BROWNS FERRY NUCLEAR PLANT, UNIT NO. 2

Amendment No. 62
License No. DPR-52

ATTACHMENT TO LICENSE AMENDMENT NO. 62

SAFETY EVALUATION BY THE OFFICE OF NUCLEAR REACTOR REGULATION
SUPPORTING AMENDMENT NO. 66 TO FACILITY OPERATING LICENSE NO. DPR-33

Figure 3.6-1

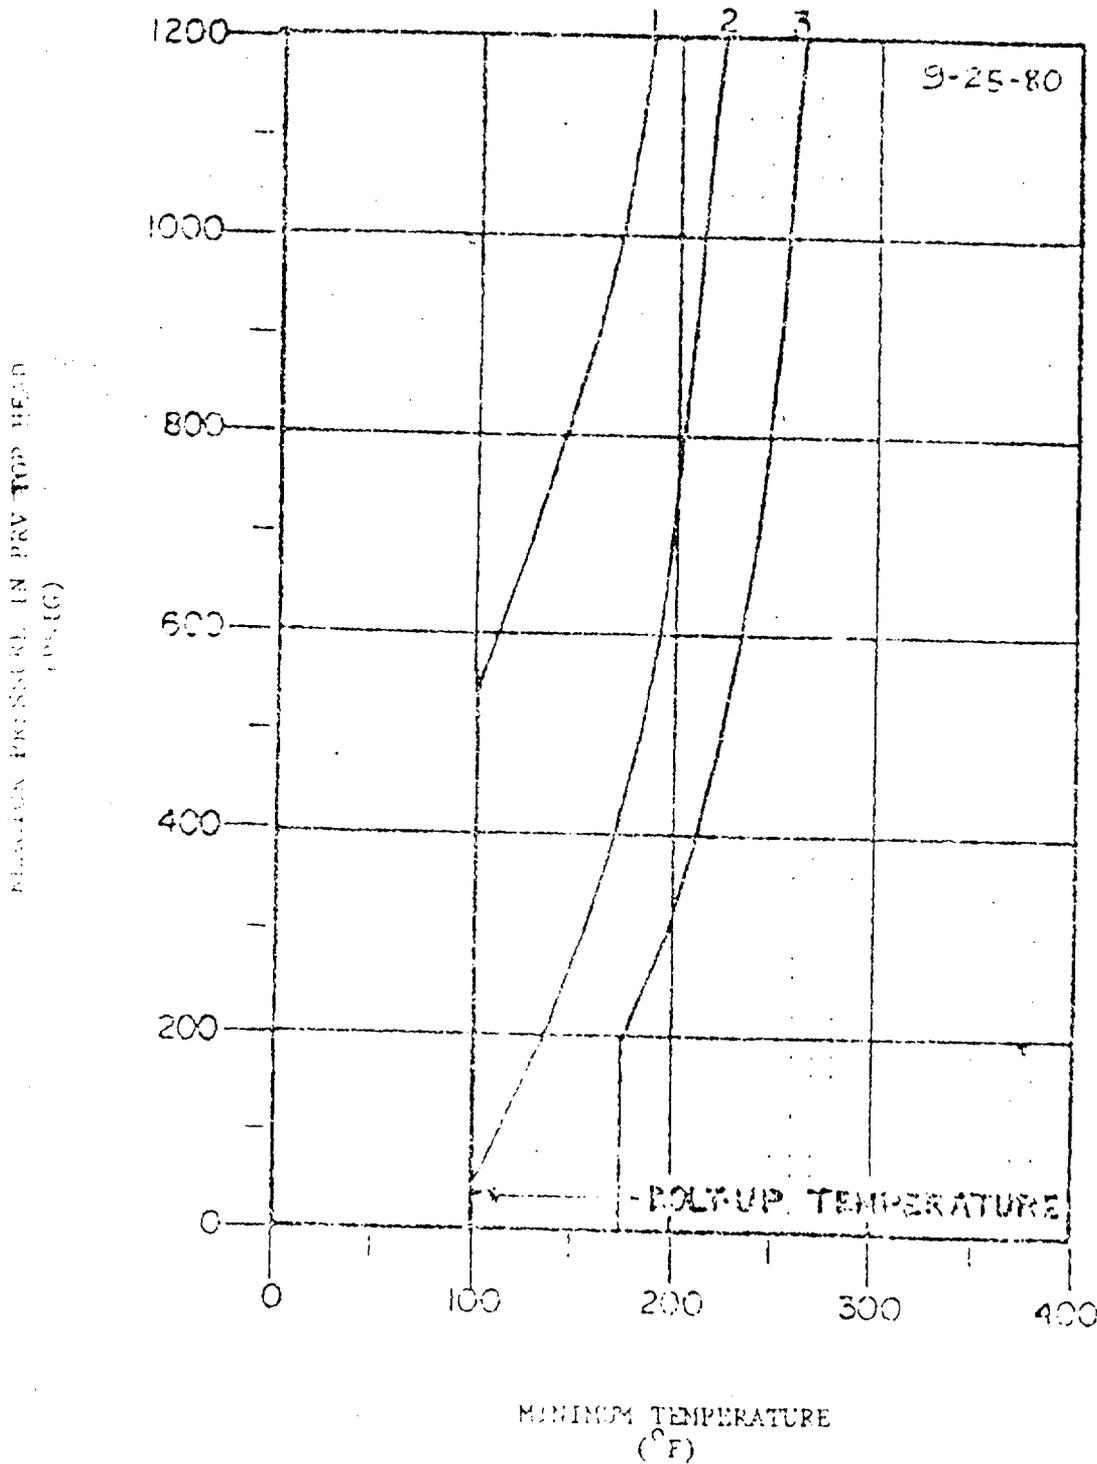
The proposed changes on page 188 of the Unit 1 and 2 Technical Specifications and on page 201 of the Unit 3 Technical Specifications is to substitute a revised Nil Ductility Temperature (NDT) operating curve. These curves specify the minimum temperature that the reactor vessel must be at for the range of primary coolant pressures. The upper portion of the curves provides an additional 20°F shift from the original curves for protection because of uncertainty of radiation damage. The lower portion of curves 2 and 3 reflect the limiting conditions for protection of the feedwater nozzles from degradation. This lower portion includes the 40°F conservatism for nuclear heatup. These proposed curves are more conservative than those in the present technical specifications and have been administratively imposed. The proposed changes are acceptable.

Curve #1
Minimum temperature
for pressure tests
such as required by
Section XI.

Curve #2
Minimum temperature
for mechanical heat
up or cooldown
following nuclear
shutdown.

Curve #3
Minimum temperature
for core operation
(criticality)
Includes additional
margin required by
10CFR50 Appendix C,
Par. IV A.2.C.

Notes
These curves are
shifted 30°F to the
right of the original
set of curves to
include a ΔK_{eff} of
30°F. This shift will
allow these curves to
used thru 4.0 EFPY.
